**MODELS** 37GQ20H

37GQ20IR

**Sharp Electronics (UK) Limited**

Reference – SP023000Y  
Revision - 3

Figure 2: Assembly details.

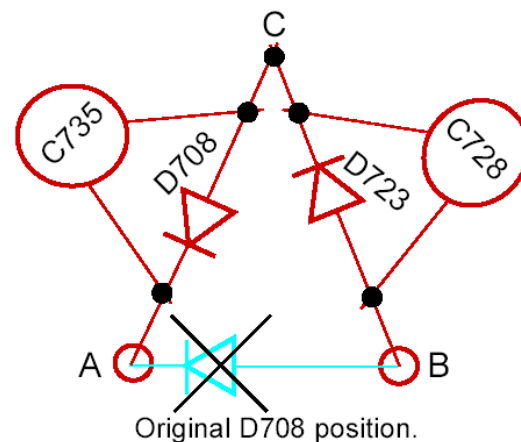
**REASON** From serial number 711112 (37GQ20H) and 800000 (37GQ20IR), D708 has been changed.

1. Change D708 value and position as in Figure 2.
2. Add D723 as in Figure 2 (B-C).
3. Add C735 as in Figure 2 (A-C).
4. Change the position of C728 as in Figure 2. to C-B.

REF NO	DESCRIPTION	PART NUMBER	PRICE CODE
D708	Diode, BYV27/600 VISHAY	RH-DX0622BMZZ	AD
D723	Diode, BYV27/600 VISHAY	RH-DX0622BMZZ	AD
C735	Capacitor 220PF 2KV	RC-KZ0035CEZZ	AC
